SECTION 42A OFFICERS REPORT PREPARED BY H BENNETT

Subdivision consent (RC220060)

9. Consent is sought to subdivide a 32.7344 hectare site into 201 residential lots, six roads to vest, one access lot, five local purpose reserves and balance land in four stages. The proposal forms stages 3-6 of a multi-staged residential development known as ‘The Clearing’ (refer to Figure 1). Stages 1-2 were granted subdivision consent under resource consent RC210185 which was approved on 28 May 2022. The current proposal will create Lots 124-324 for residential activities with lots ranging in size from 400 m² to 1,028 m² and a balance lot (Lot 5000). Lots 1002-1004 and Lot 1007 will be vested in the Council as road with Lots 1005 and 1006 to be vested as road with Waka Kotahi New Zealand Transport Agency. Lot 602 is an access lot. Lots 3004-3008 will be set aside as local purpose reserves (utility) to be vested in the Council.

Figure 1: Overall subdivision scheme plan

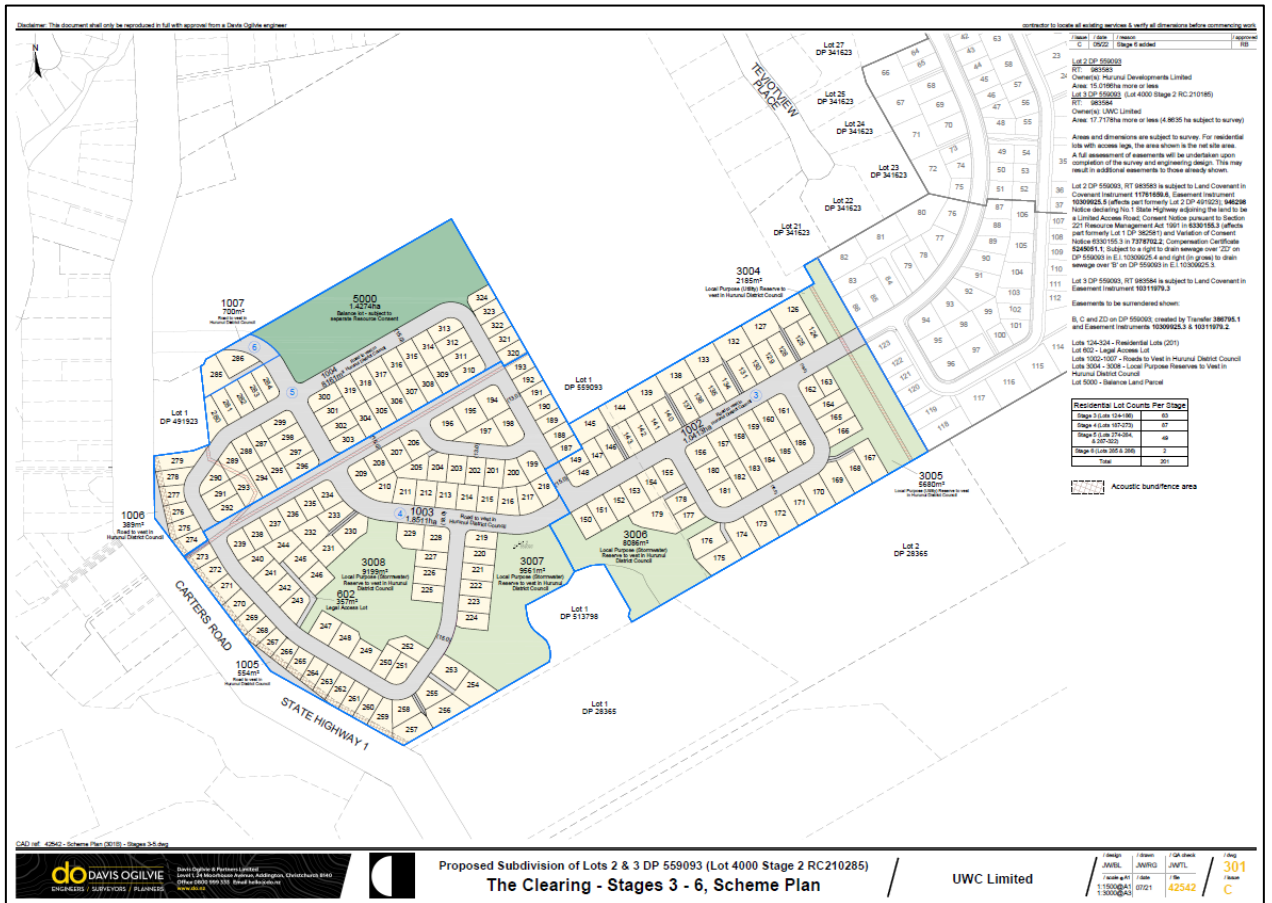
58. The proposed subdivision creates 201 lots ranging in size from 400 m² to 1,028 m² with an overall average lot area of 542 m². In addition, the proposal provides for 87%, or 175 of the lots to be less than 700 m² in area. Furthermore, the District Plan also specifies that lots adjoining the Rural Zone are required to be a minimum of 1,100 m² in area. The twelve lots fronting onto the Rural Zone do not meet the minimum area requirement with these lots ranging in size from 703 m² to 771 m² and having an average area of 732 m². In addition, 19 of the lots will not meet the 15 m by 15 m shape factor requirement.

66. In relation to the rural / urban interface, Ms Smetham is concerned that the two clusters of undersized lots along the southern boundary of the site, will introduce an urban outlook to the adjoining Rural Zone, will limit tree planting and may arise in potential reverse sensitivity effects. She notes that lots adjoining the Rural Zone can readily comply with the minimum lot size and should do so to reflect an open space character and transition to the adjoining rural landscape that is consistent with the balance of the peri-urban interface surrounding the Amberley Township.

69. I concur with Ms Smetham in that I consider that the provision of a post and rail or post and wire fence along the southern boundary would be appropriate. While the proposed master plan shows a landscape buffer along the southern boundary of the site, it is not clear whether this is intended to be 5 m wide and what this planting will be comprised of. While I consider the provision of a landscape buffer and building setback, would go some way towards mitigating the effects of the increased lot density along the rural boundary, I do not consider that the proposal would protect the landscape character and visual amenity from the adjoining Rural Zone.

86. While the Applicant has demonstrated that some of the lots that do not comply with shape factor can accommodate a dwelling with a bespoke design, I consider that the proliferation of both undersized lots and lots that do not comply with the shape factor requirement will inevitably result in a series of land use consents being applied for to breach setback, recession plane and site coverage requirements as has been seen in other recently completed subdivisions. I note that the majority of building consents lodged with the Council are not for bespoke design dwellings but rather standard design plans from housing companies. Of particular concern are smaller lots located at the intersection of two roads where there is more than one road frontage (4.5 m setback required) for example in the case of Lot 290.

154. I consider that post and rail or post and wire fencing along with a 5.0 m wide landscaping buffer comprising of native plant species should be provided along the south boundary of the site to maintain an appropriate rural / urban interface.

Figure 2: Site and staging plan for retirement village on adjoining land to the north

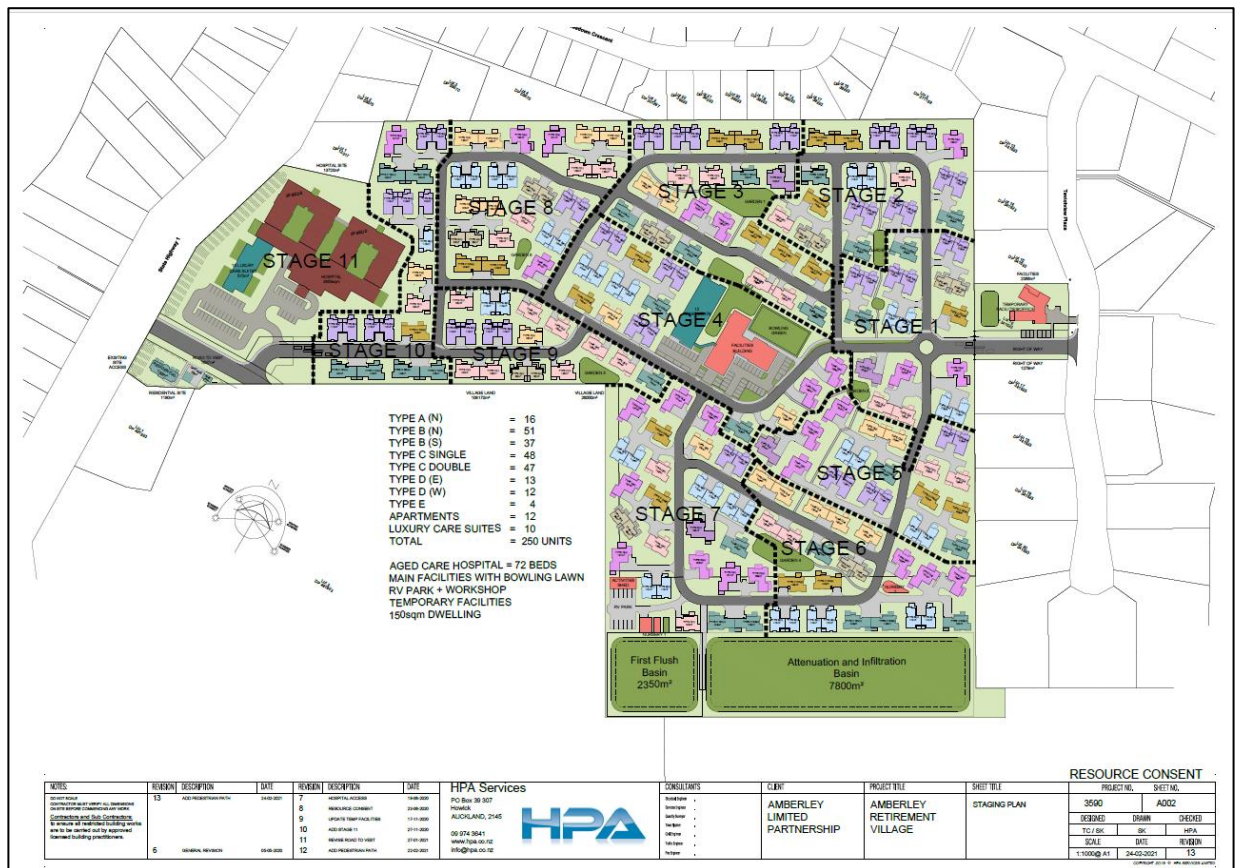
146. However, I note that the new road connection to SH1 is predicated on the new road and intersection being formed as part of the adjoining retirement village development (refer to Figure 2). However, I note that the retirement village consent was for a land use consent only and as such there is currently no mechanism that I am aware of to ensure that the proposed new road to the intersection will be vested in Council as this usually occurs by way of a condition on a subdivision consent. The conditions of consent for the retirement village require that only stages 1-4 (or 100 units) may be developed and occupied until such time as the formation of the intersection of the internal road and SH1 have been completed and operational. I understand that at this time, only stage 1 has been completed and approximately half of the units in stage 2 have been granted building consent (a total of 27 units have been consented to date).

148. While I have some concerns regarding the timing and provision of the link through to the new road and intersection with SH1 to be created as part of the adjoining retirement village, I am otherwise
